PUBLICATION INDEX FOR SGS 1-35

K & L SOARING, LLC
5996 STATE ROUTE 224
CAYUTA, NY 14824

BULLETIN NO. SA-001.6*

SUBJECT: ONE-TIME INSPECTION OF TOW RELEASE ASSEMBLY; DAILY INSPECTION OF TOW RELEASE ASSEMBLY; PILOT'S PREFLIGHT INSPECTION OF TOW RELEASE ASSEMBLY; 100 HOUR/ANNUAL INSPECTION OF TOW RELEASE ASSEMBLY.

FIGURE 5. STRUCTURAL DOUBLER ID PATCH

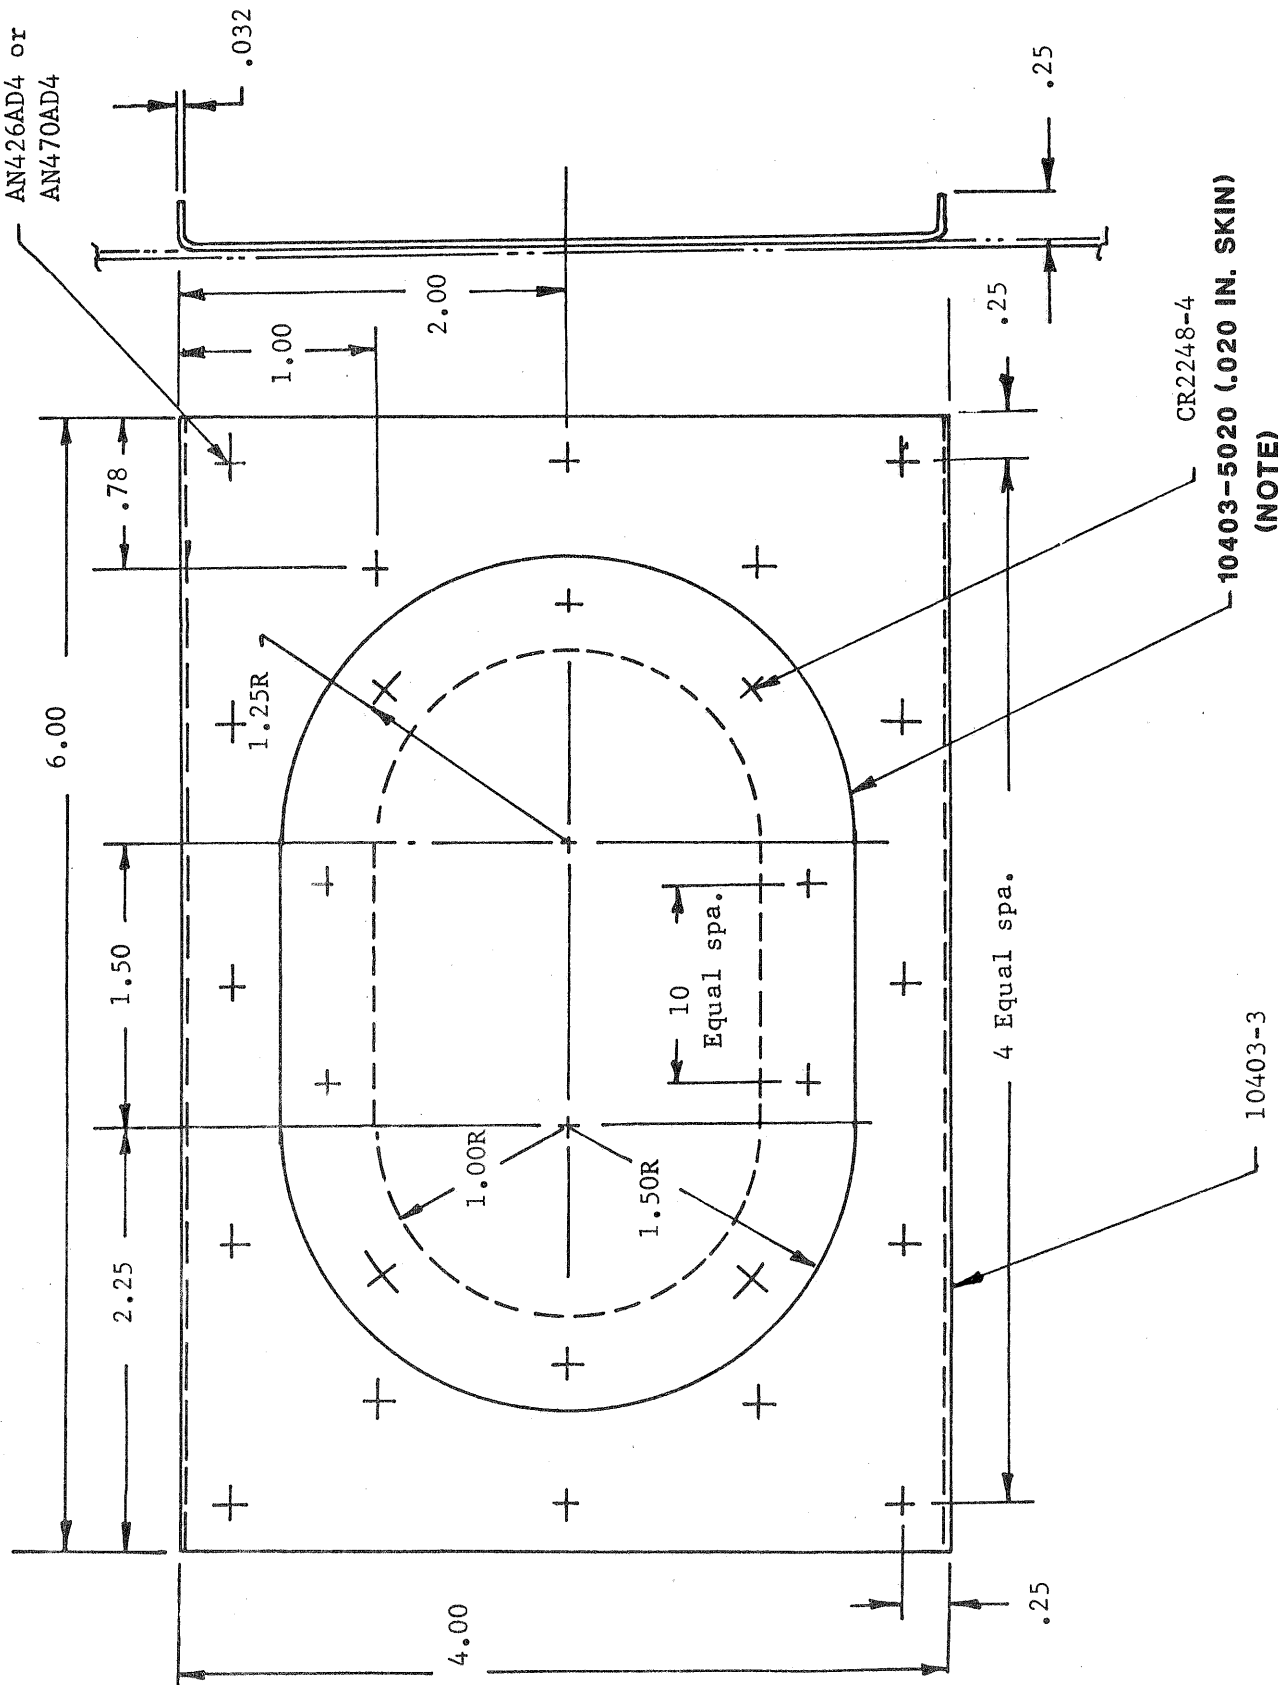
- (2) Use vacuum cleaner with flexible extension hose to remove debris from lower portion of tail fin.
 - (3) Using doubler as a template, install appropriate number of rivet holes (of proper size) in tail fin skin at locations shown in Figure 5.

- (4) Slide doubler through access hole, rotate it 90 degrees, and use appropriate rivets (Figure 5) to fasten doubler to fin skin.
 - (5) Secure patch to doubler with rivets. (Refer to Figure 5.)

Doubler
.032 2024-T3 Alc.
NOTE: EARLY SGS 1-35 SAIL PLANES WHICH INCORPORATE
A .016 IN. SKIN REQUIRE A 10403-5016 PATCH.

LE:	FLAP TORQUE TUBE - FUSE.						CHG. LET.
CHG. INC.		EFFECTIVITY	ALL A/C	PARTS AFFECTED	_____	ECO. SERIAL	35-264
BY	A. HAUCK	CARD POSTED	7-7-75	TOOLS AFFECTED	_____	D. C. R. SERIAL	_____
DATE	7-7-75	CHECKED	A. L. L.	STOCK DISPOSITION	REWORK	DWG. NO.	35-264

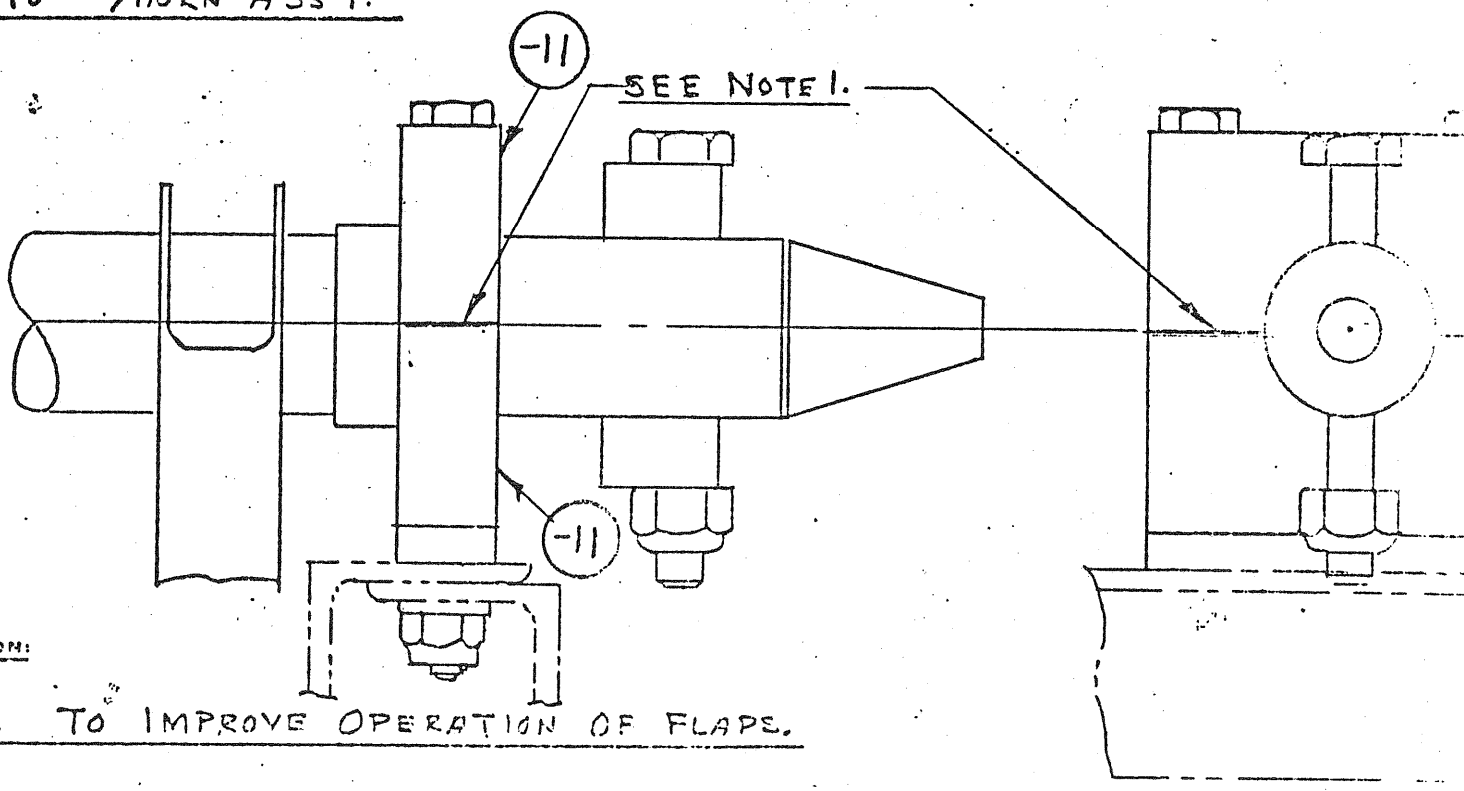
There have been 2 cases of flap buzz or flutter at speeds of about 60 - 70 mph. In both cases it stopped by applying a small amount of flap, either positive or negative flap. It appears that at this speed range the flap is not subject to any damping airload at 0° flap position.

It appears from the owner's reports that the flap free play was .250 or more. This was free play with light hand pressure at trailing edge of the flap at the fuselage. More firm pressure will show more free play due to the tolerance in the fuselage flap control. To insure that the fuselage free play does not affect this, we are enclosing the attached rework Engineering Change Order No. 35-264.

Check your aircraft using the light pressure, about 2 - 3#, and if your free play exceeds .125 please advise us. If the free play approaches 3/16" do not fly until rework is accomplished per our instructions.

1. WITHOUT PUSH ROD ATTACHED ADJUST (1) PAIR OF -11 BEARING BLOCKS (L.H.) TO GIVE A FRICTION TORQUE ON TORQUE TUBE OF 5-8 IN. LBS. -11 BLOCK MAY BE FILED LIGHTLY TO ACHIEVE THE FINAL RESULT. WING PANELS SHALL BE REMOVED WHEN DOING THIS MOD.

2. F/D. ADD: SEE NOTE 1. TO CENTERLINE OF (2) -11 BLOCKS ADJACENT TO -7 HORN ASS'Y.

1. - 2. TO IMPROVE OPERATION OF FLAPS.
